Validation Opinion for Post Registration Changes

Report for:
M/s CLP Wind Farms (Khandke) Private
Limited

CDM project for
“Roaring 40s Wind Farms (Khandke)
Private Limited - Phase III”
(UNFCCC ref: 3611)

LRQA Reference : CDM-MUM-0061835
Date : 25/01/2013

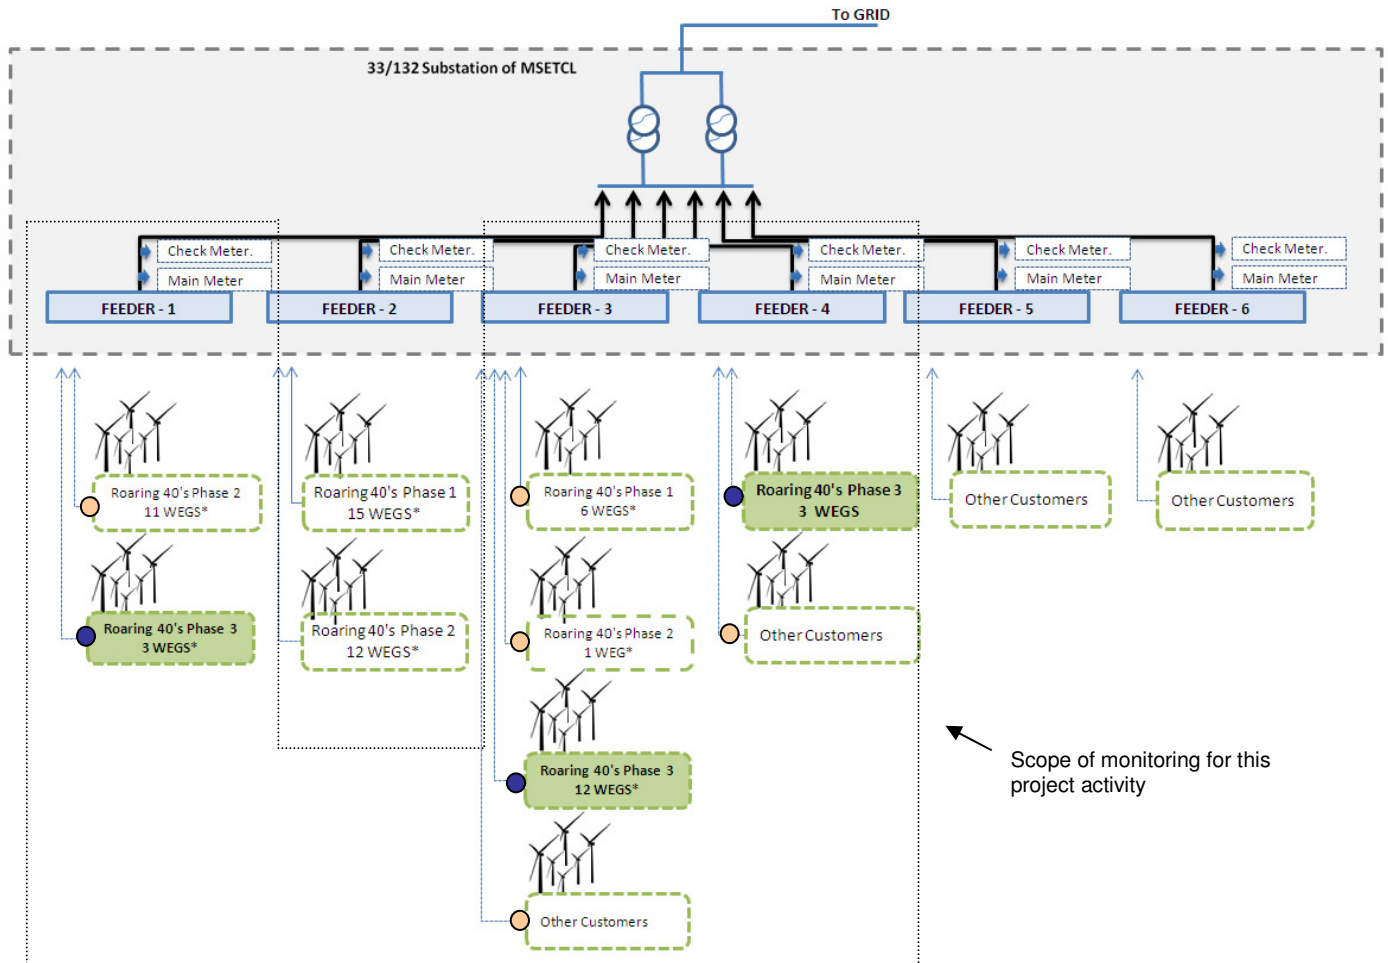
Further in section B.7.2 a line diagram and apportioning procedure is included in the revised monitoring plan for clarity and transparency. Based on site assessment and verification of documents, the team confirms that the provided line diagram and the apportioning procedure reflects the actual monitoring practices and procedures.

The electricity export to the grid and import from the grid, from the WECs connected to feeder1, feeder 3 and feeder 4 is measured through the main and check meters installed at the 33kV side of the Substation. The above line diagram indicates the location of the feeders at the substation and the local control system (LCS) meters at the WECs. Joint
